January 31, 2025

Re: Response, Whirlwind Mine, Permit No. M-2007-044, Technical Revision
(TR-2), Adequacy Review-1

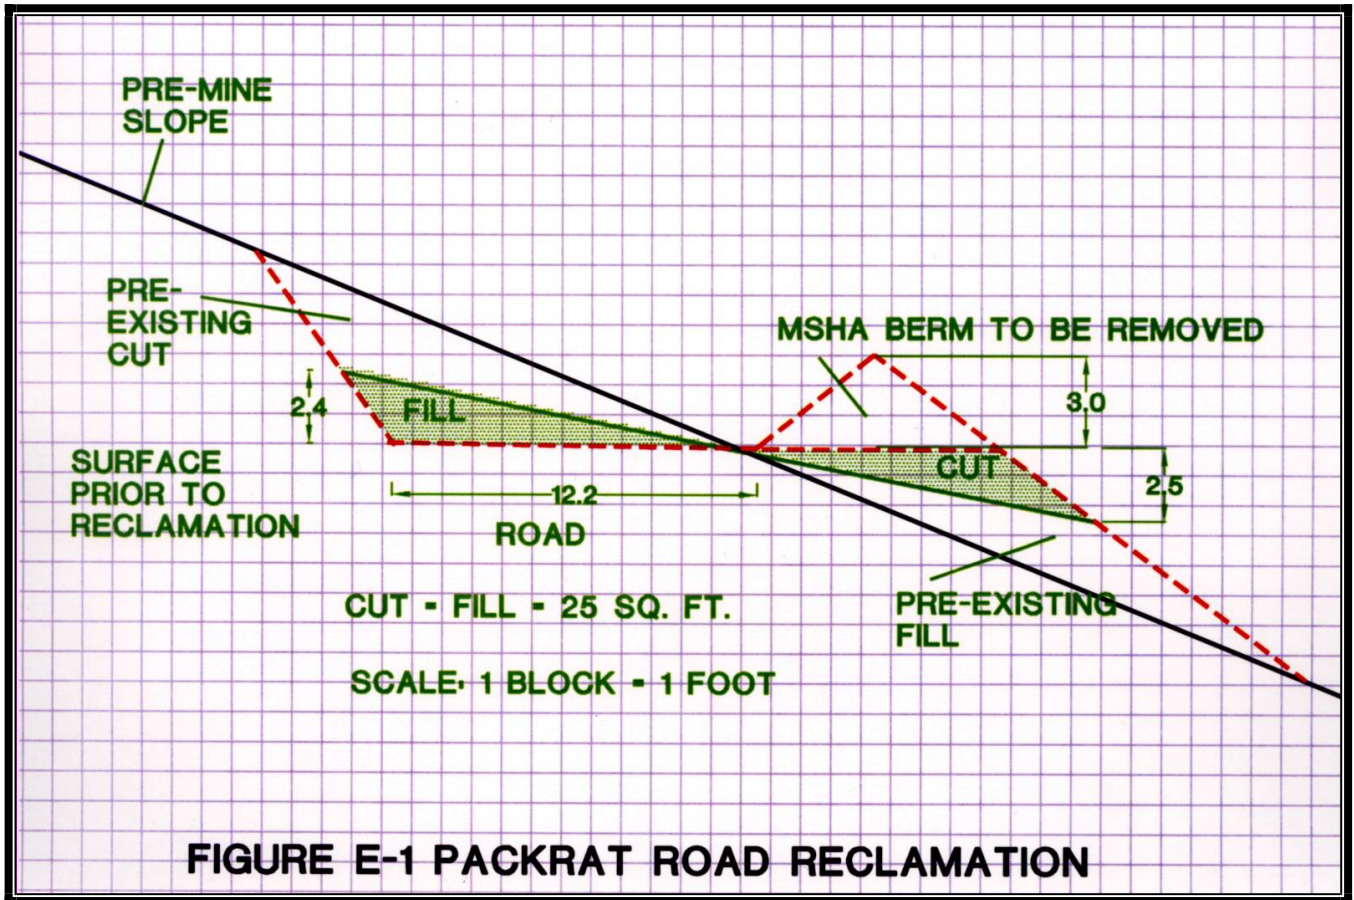
4. What is the new total LF of 6 ft H chain link fencing that will require removal at the Whirlwind. Additional fencing is necessary to enclose the two Linkan trailers in addition to the existing water treatment system. There is also fencing along the dry room trailer. Previously a total 1100 LF was noted, please state the new total.

EFRI Response: The amount of fencing remains the same as what is already listed. The existing fence will be moved out to encompass the two Linkan trailers. See the attached illustration depicting EFRI's intent to push the existing fence diagonally outward approximately 100-feet. It is worth noting that this ground is already disturbed, and no new disturbance is required for the addition of the two Linkan trailers.
